CITY OF MADISON  
**INTER-DEPARTMENTAL**  
CORRESPONDENCE

DATE: January 28, 2008

SUBJECT: **Agenda Item 8- 901 Lake Court**

Map from Zoning Administrator indicating the general location of the floodplain and the location of the proposed garage.

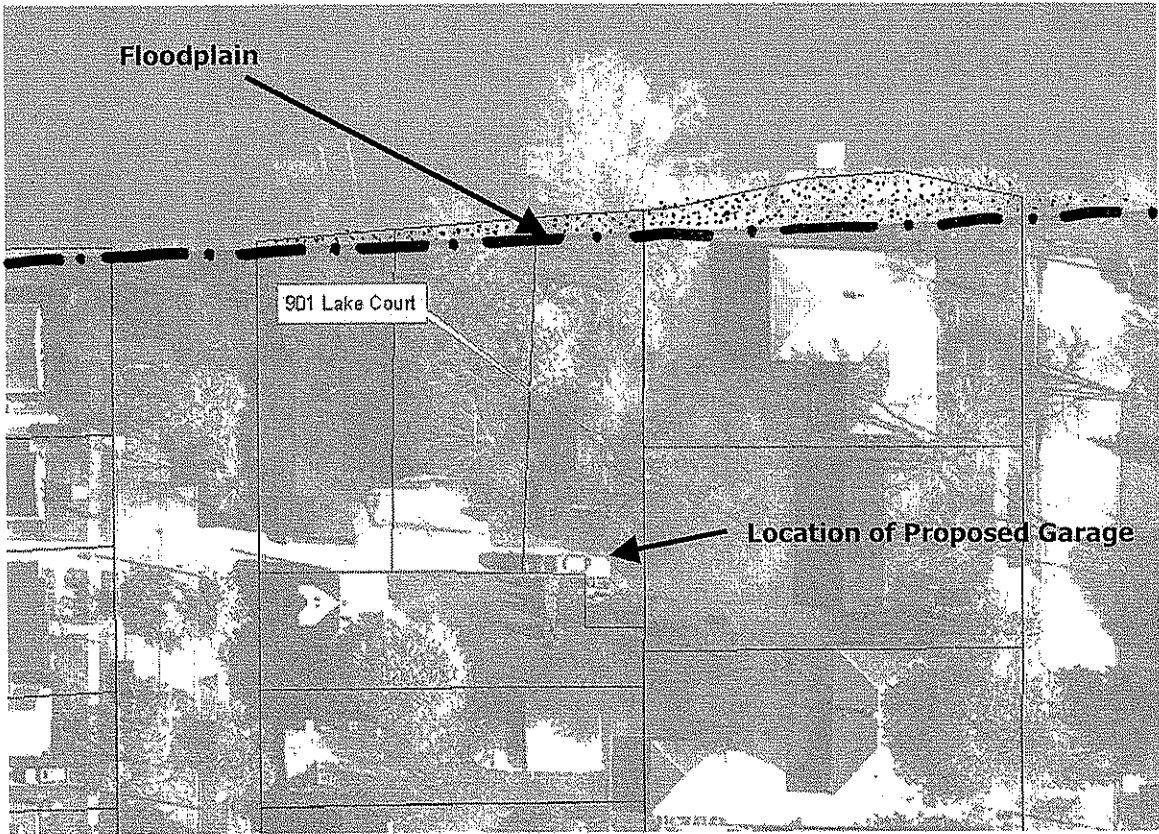
Attached to this message is a map of the subject property, showing the property lines (red), floodplain (yellow area with blue border), and the aerial photo background. It looks like only a very small part of the lot, near the shoreline, is located in the mapped floodplain area. In this case the principal structure and the proposed accessory structure are clearly not located within the floodplain area and therefore have no floodplain-related issues or concerns.
